## REGULAR MEETING CONSERVATION COMMISSION

4:00 P.M. July 9, 2025

## Memo

SUBJ: July 9, 2025 Conservation Commission Meeting

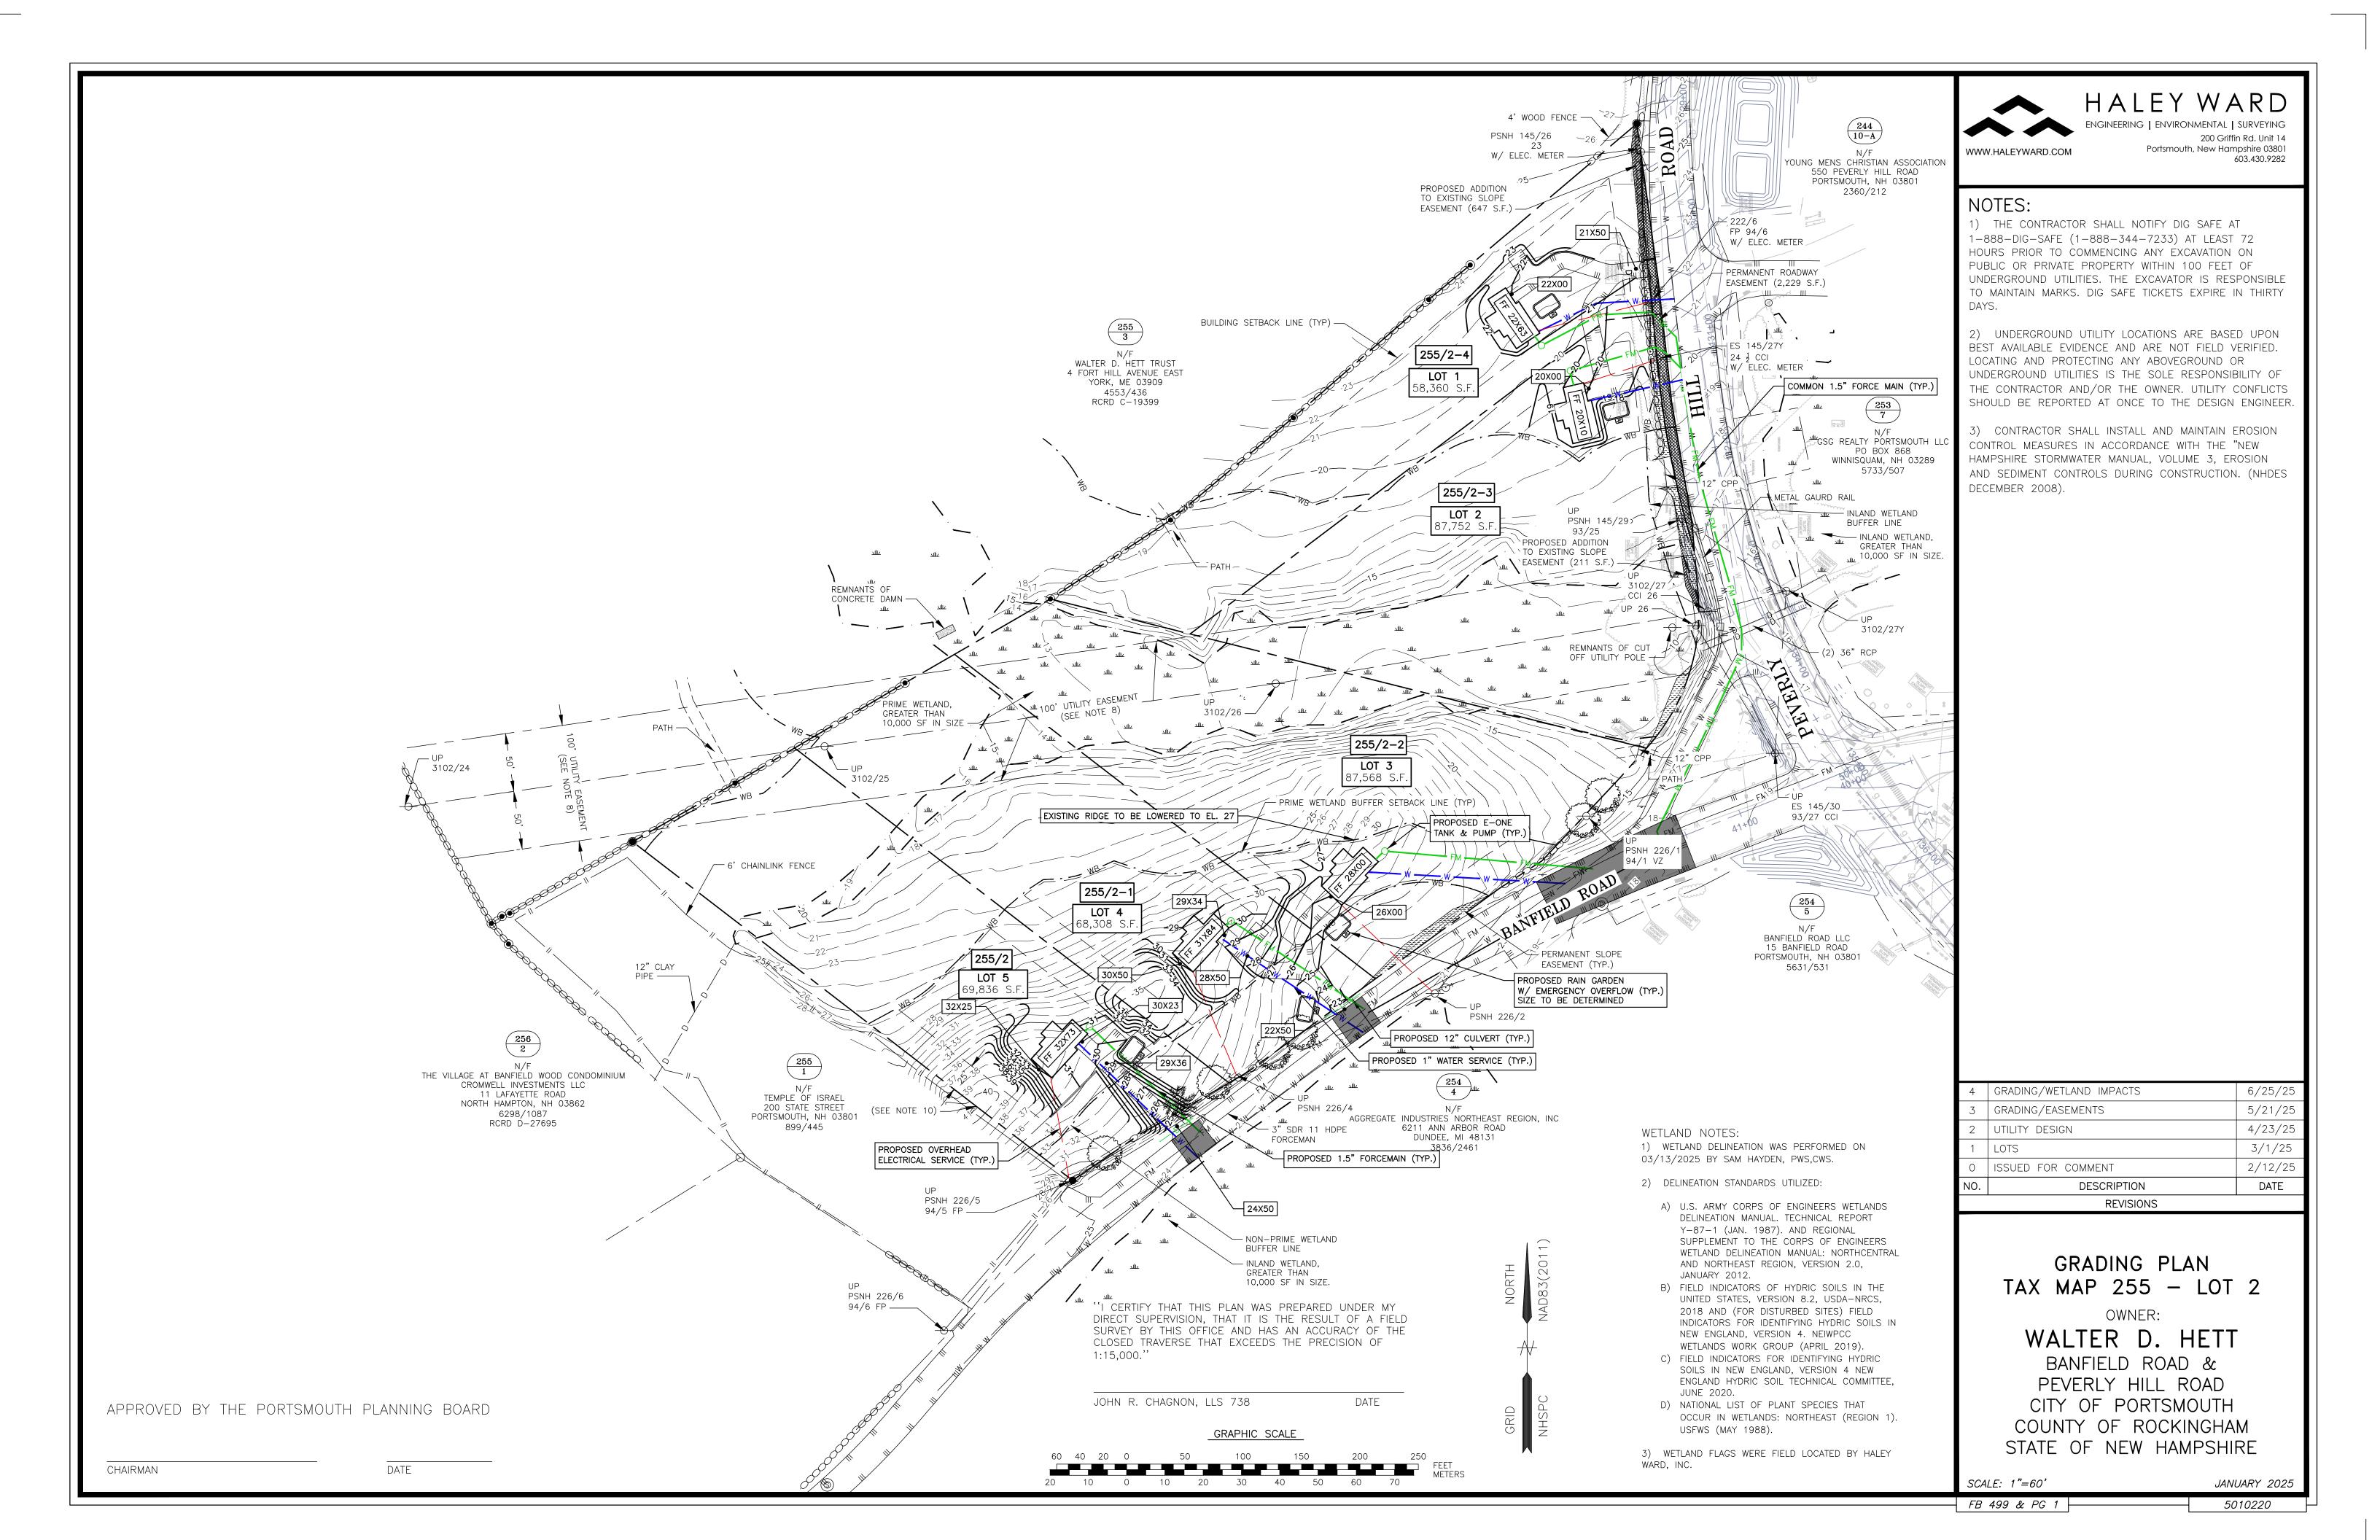
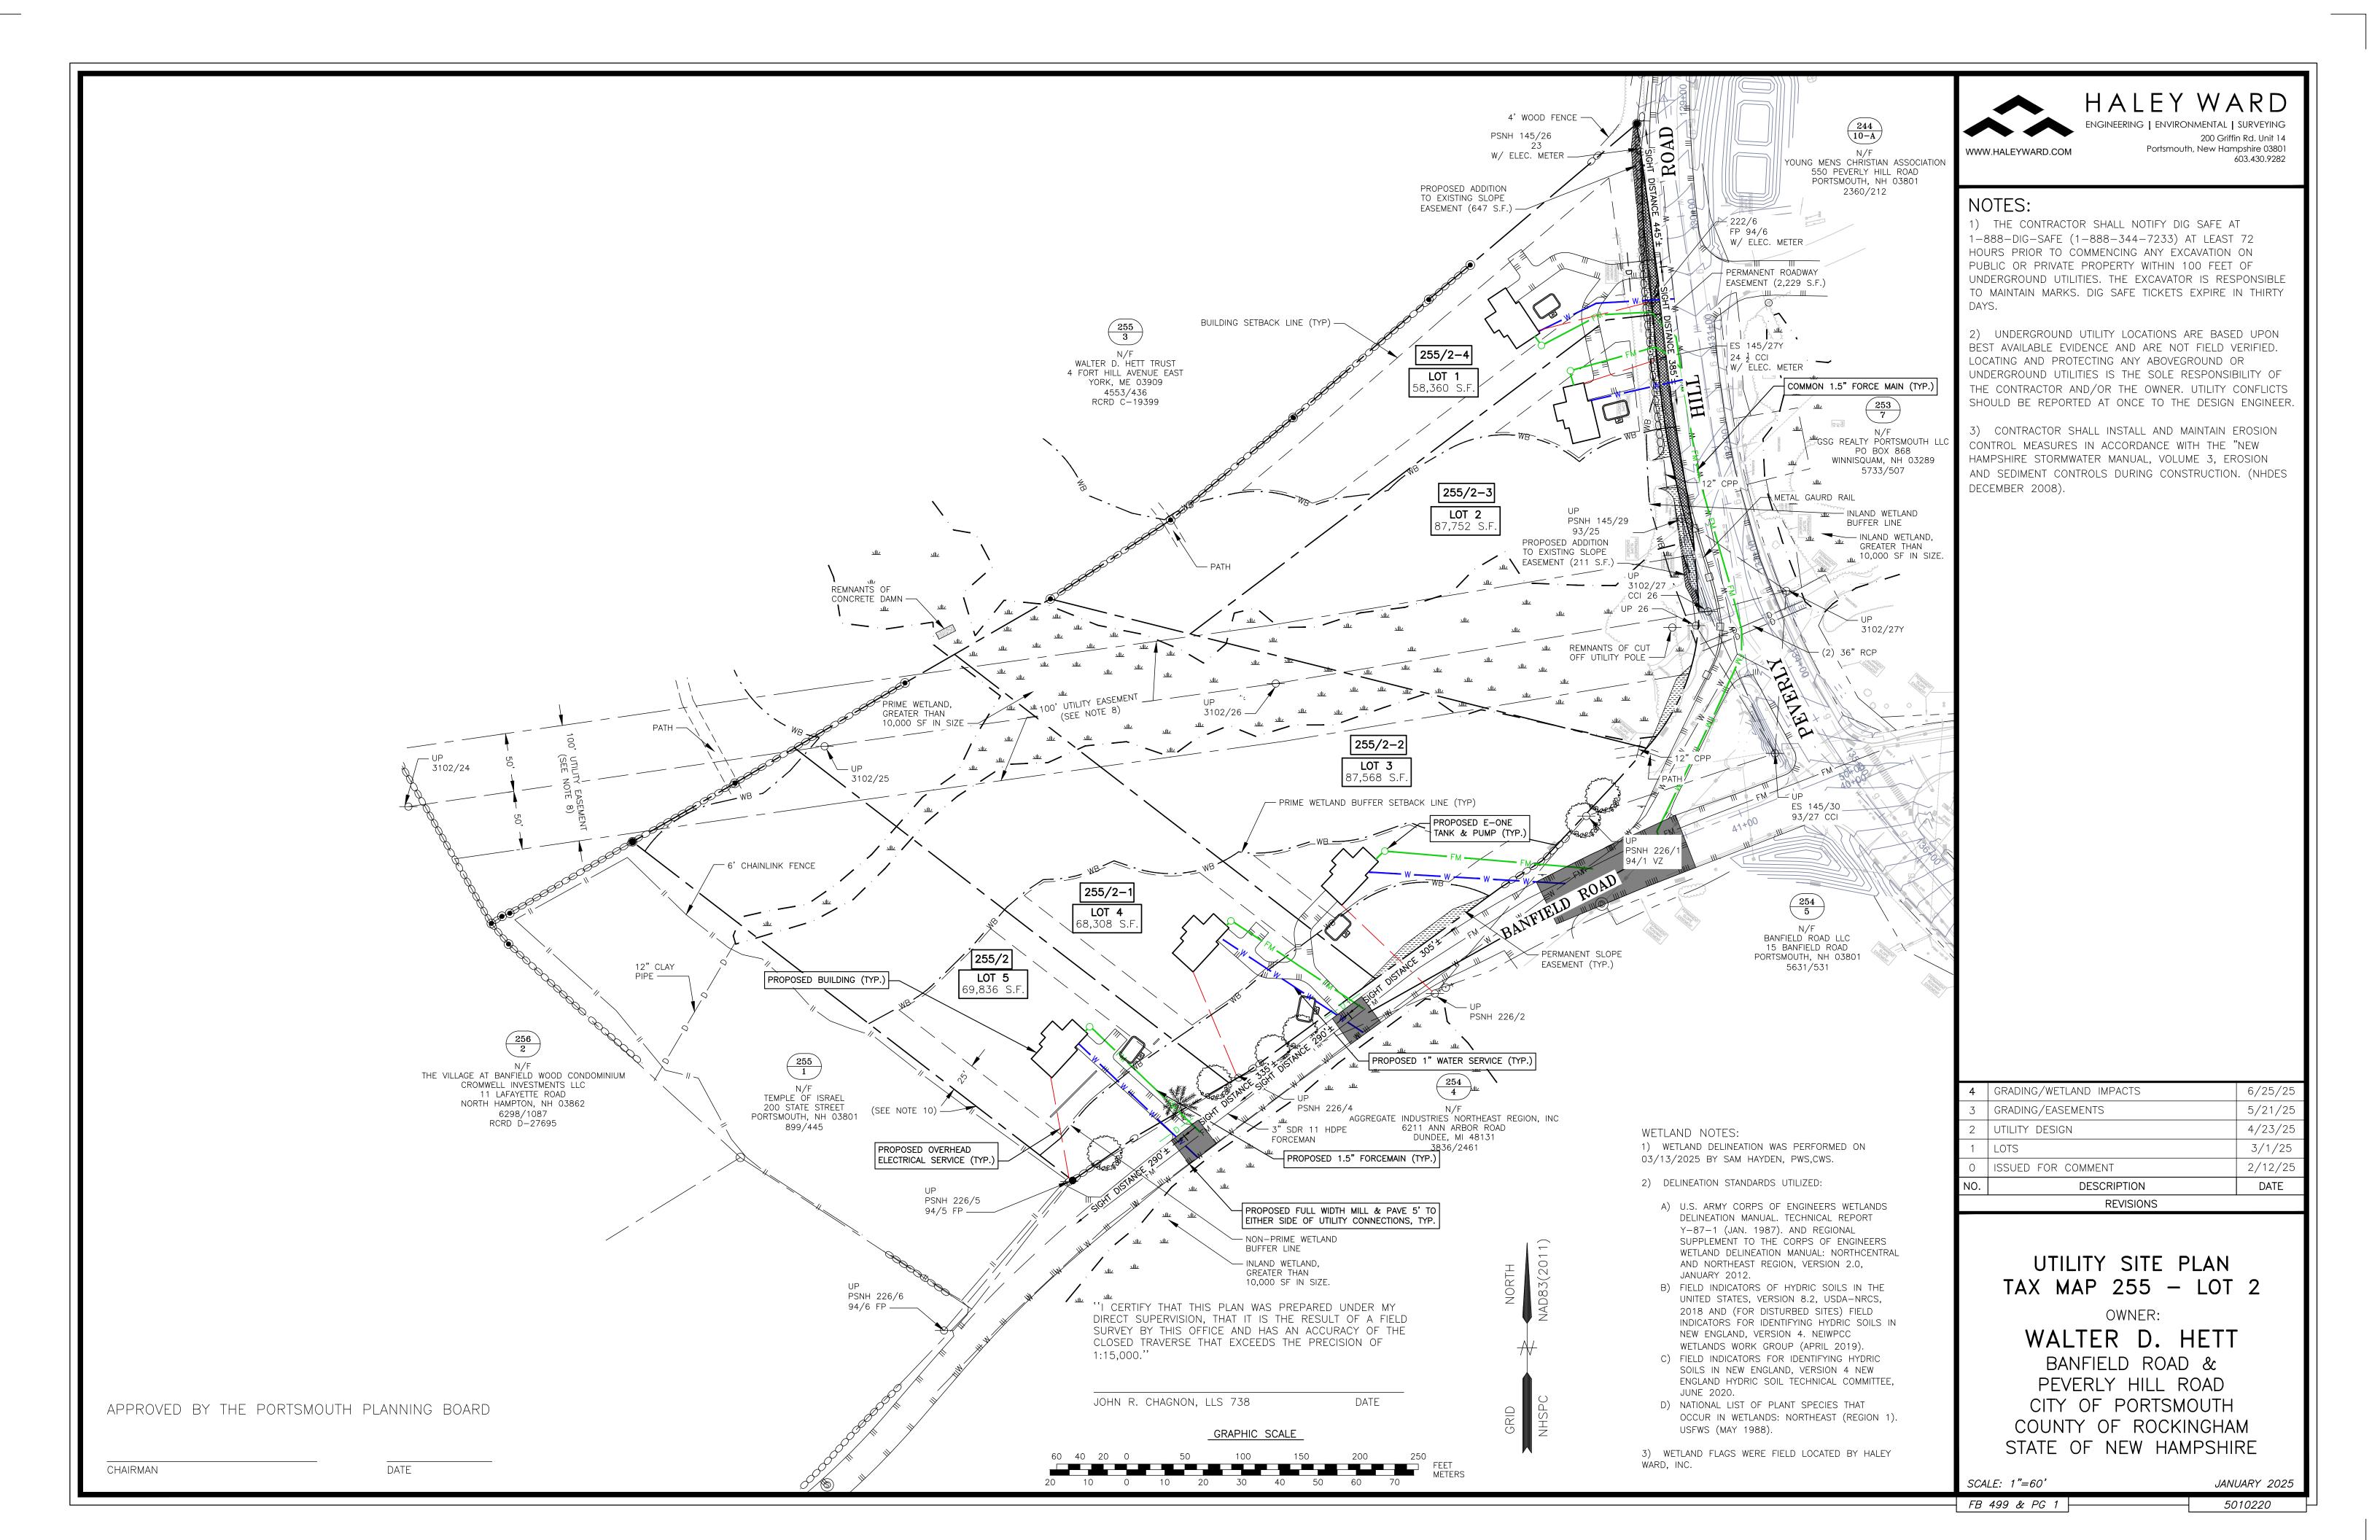
Impacts to the buffer include new impervious surfaces and construction of new utility and stormwater services. Applicant needs to show how stormwater runoff on site will be retained and treated. Current stormwater plans need to be finalized, and an erosion control plan must be provided.

The construction of the new services and driveways will likely have impacts on the existing tree line along Banfield and Peverly Hill Road. Applicant should clearly mark the trees to remain and to be removed on the plan set.

A planting plan is needed to determine this.

- 1. Wetland delineation shall be certified and stamped by a NH Certified Wetland Scientist (CWS).
- 2. Applicant should explore alternative plan with one shared driveway entering Lot 3 between the buffer setbacks to provide access to Lots 4 and 5.
- 3. Exact dimensions, location and a detail sheet are needed for the proposed rain gardens.

- 4. Erosion and sediment control plans must be included in this application, not just the building permit phase.
- 5. Application checklist is not complete, please address how this application complies with the following sections in the City of Portsmouth Zoning Ordinance:
  - a. 10.1017.24
  - b. 10.1017.25
  - c. 10.1018.31
  - d. 10.1018.32
  - e. 10.1018.40
- 6. Applicant should propose buffering or protection along each of the lots that protects the natural vegetated state of the prime wetland and its 100' buffer to the rear of the site.
- 7. Applicant shall include a planting plan in the plan set. This should also show vegetation to remain and to be removed.
- 8. Applicant must clearly define and address areas to be filled and areas to be regraded on the plans.
